Re: District Department of Transportation Report and DC Office of Planning Report
BZA Application No: 18638, Rosebusch LLC and Gregg M. Busch

Case # 18638
Mesterhazy supplemental letter in opposition

BOARD OF ZONING ADJUSTMENT
District of Columbia
CASE NO. 18638 EXHIBIT NO. 32
Board of Zoning Adjustment
District of Columbia
CASE NO. 18638
EXHIBIT NO. 32

ATTACHMENT A
BZA Case 17459 - Adjacent Church St. Condominiums

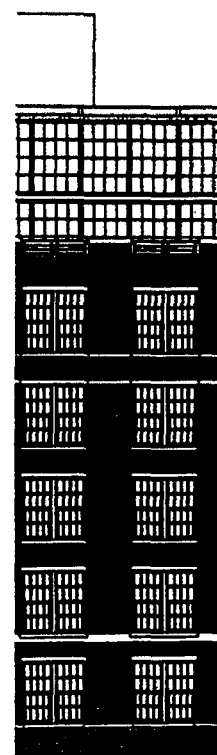
The BZA file for the building immediately to the east and adjacent to the subject properties notes that the allowable building height is 70'. Per the plans for that building, it was constructed to 70'. (See BZA file # 17459 and the attachment). There is no difference in the size of the right-of-way of Church Street or any other factor that I can identify that would allow a project at the subject site to exceed the 70' limit of the Height Act. (Of note, in my October 17, 2013 letter I also pointed out that the applicant's graphics that show the measured height of the proposed building at 75' but also show the proposed building to be the exact same height as this existing building immediately east on Church Street—which is 70').
